3. Corrections and Additions

As required by Section 15088(d) of the CEQA Guidelines, this chapter provides corrections or clarifications to the Draft EIR. None of the corrections and additions constitute significant new information or substantial project changes, as defined by Section 15088.5 of the CEQA Guidelines, and thus, recirculation of the Draft EIR is not required. The changes to text and graphics contained in the Draft EIR are indicated below under the corresponding Draft EIR section heading. Deletions are shown in strikeout text and additions in underlined text.

SECTION 3.1 - TRANSPORTATION

Page 3.2-5 – Revised Figure 3.2-1 Landscape Unit Overview as follows:

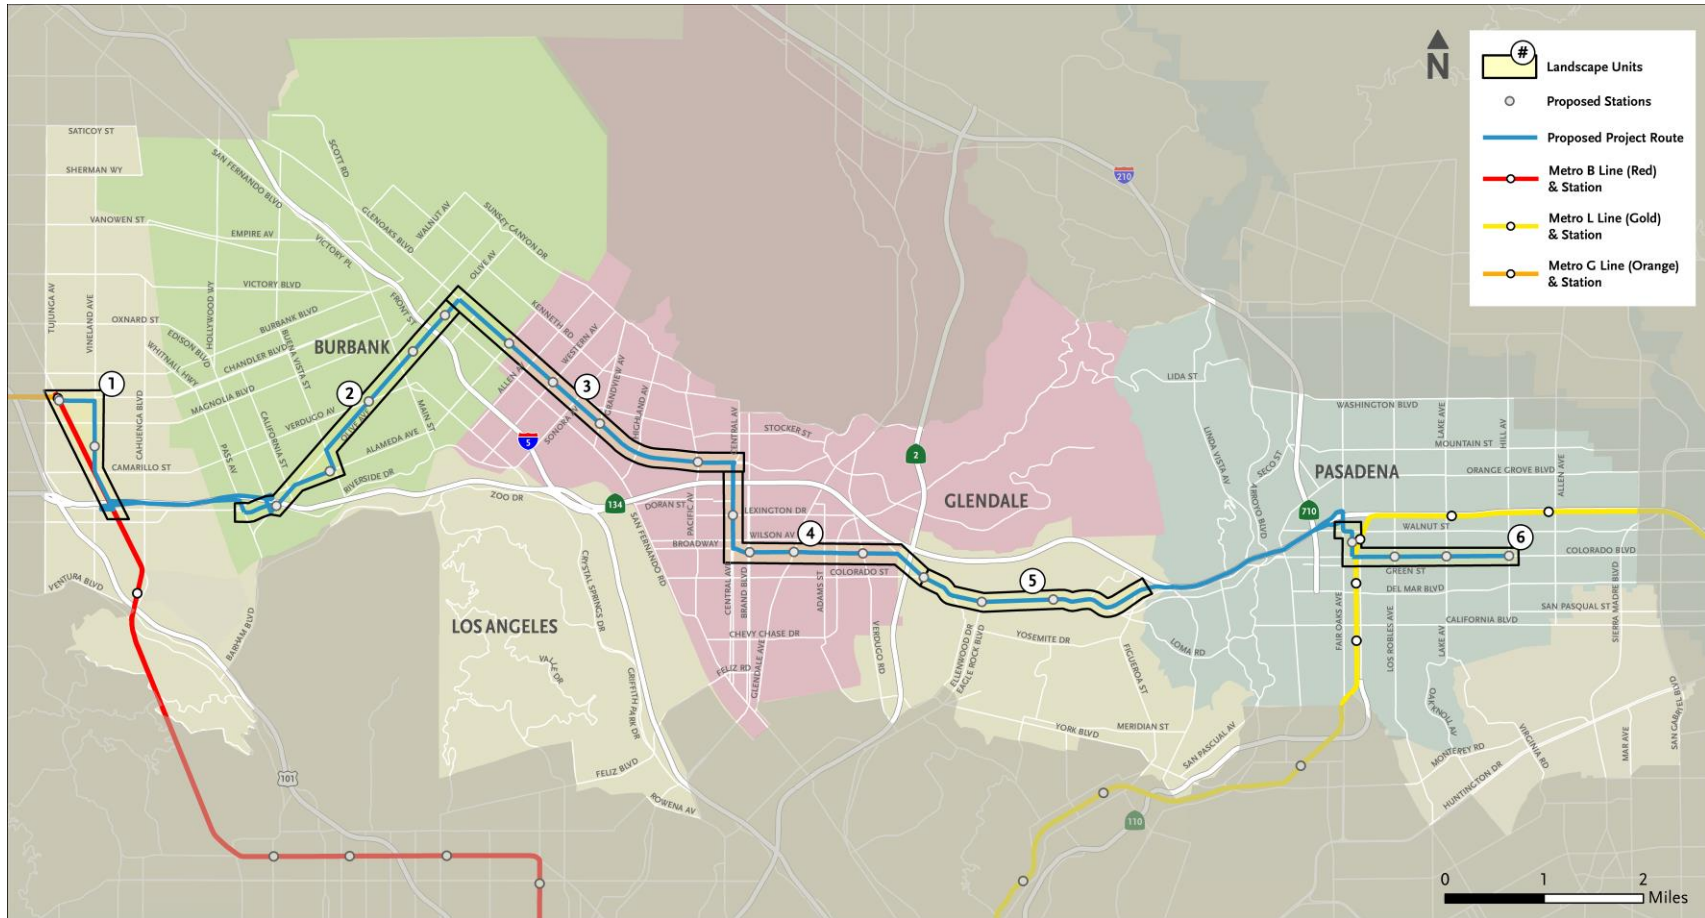
Page 3.2-4, last paragraph – delete references to route options as follows:

To illustrate the existing visual setting, representative landscape units (LUs) were selected to provide a summarized description of the visual character and quality of the Project Area as well as an account of visual resources present. An LU is a portion of the regional landscape and can be thought of as an outdoor room that exhibits a distinct visual character. The LUs were selected based on geographic and jurisdictional divisions along the route ~~and route options~~ with a focus on the visual consistency among development patterns, visual resources, and overall character. Each LU is delineated on maps and numbered from LU-1 to LU-6. **Figure 3.2-1** provides an overview of the LUs

Page 5-4 – Revised Figure 5-1a – Related Projects as follows:

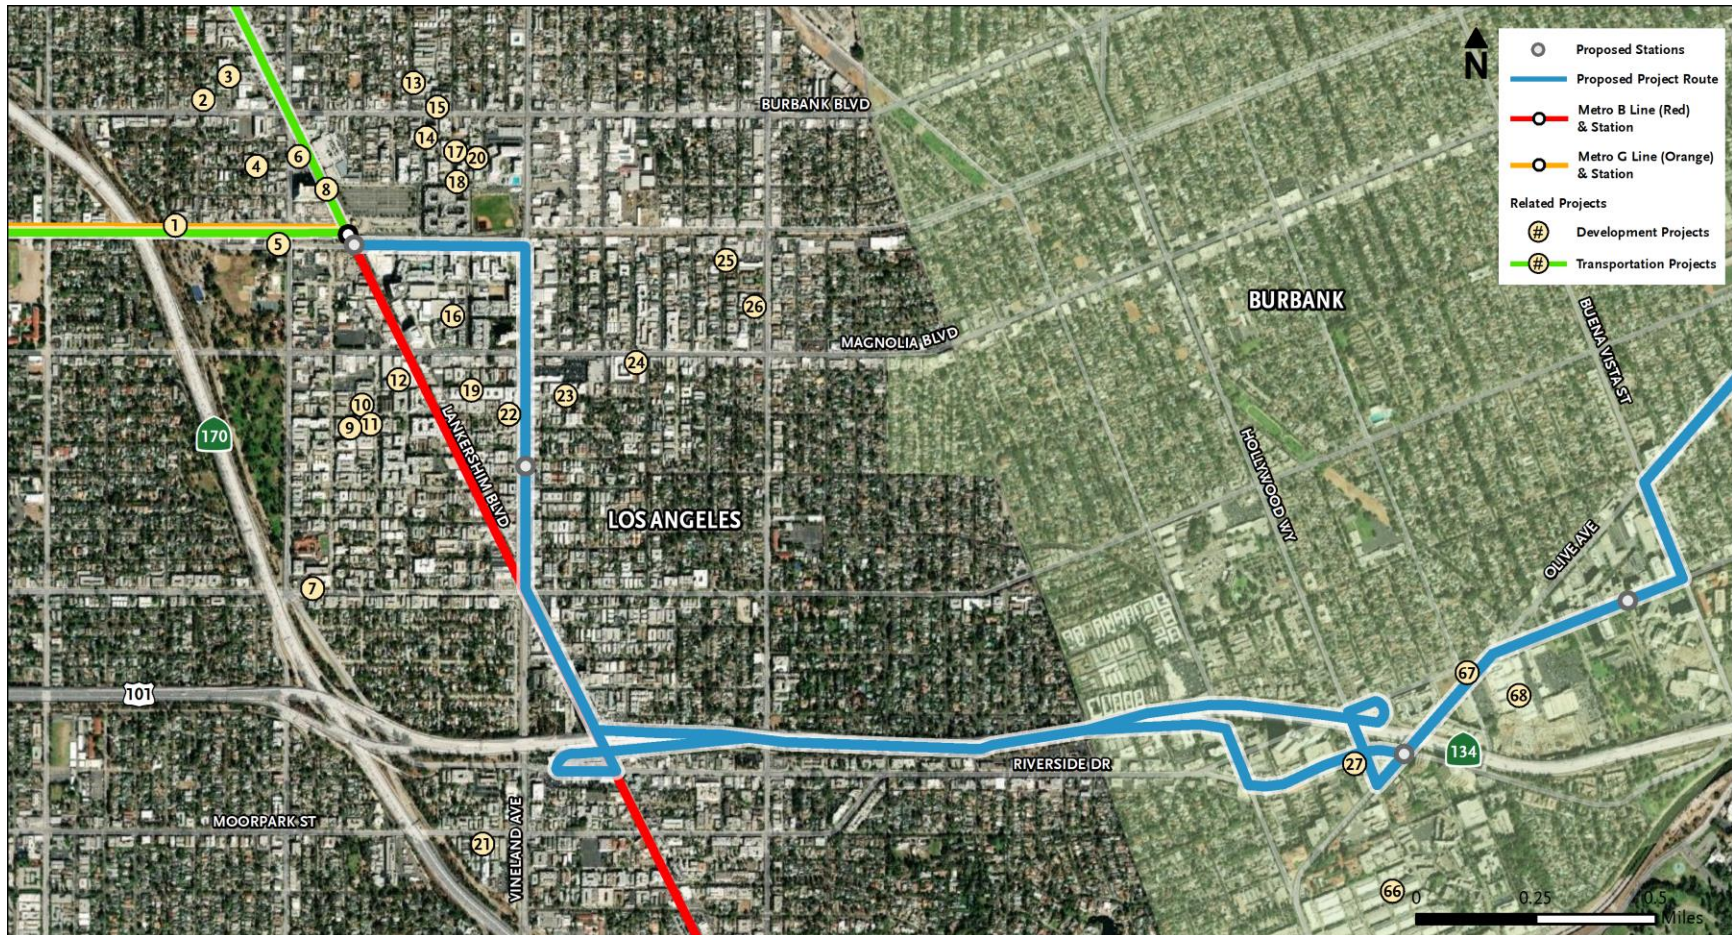
Page 5-7 – Add the following projects to **Table 5-2**:
